Detailed Site Plan Norbourne Property

DSP-08035-02

REQUEST	STAFF RECOMMENDATION
An amendment for the addition of three new Ryan Homes architectural models.	APPROVAL

STAFF REPORT

Figure 1: Proposed Architectural Elevations

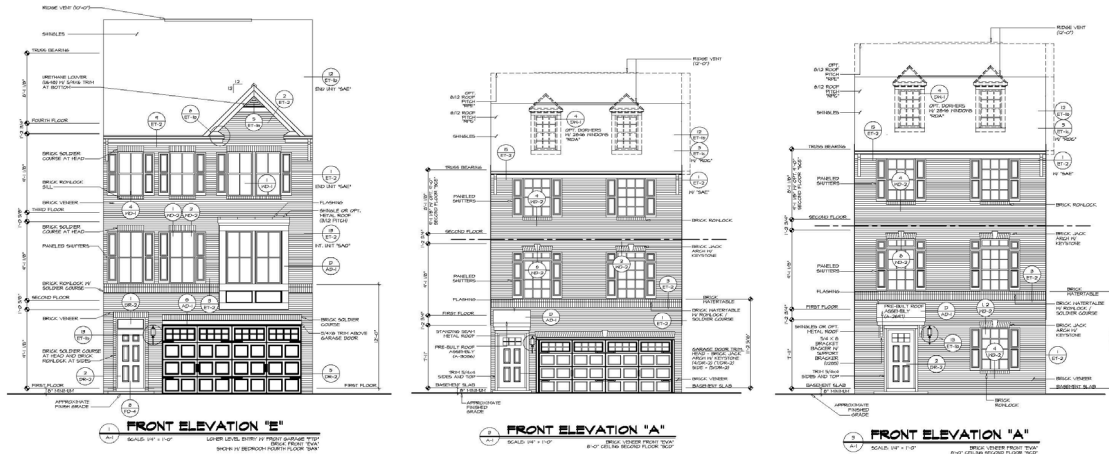
Staff notes that no side elevations were submitted for the Schubert D and Schubert E models. This is because these 22-foot-wide models will only be located on the interior of the townhouse sticks. The end units on the townhouse sticks are all proposed to be 24-foot-wide and will use the McPherson and McPherson Grande architectural models, which propose side elevations and options for highly visible units.
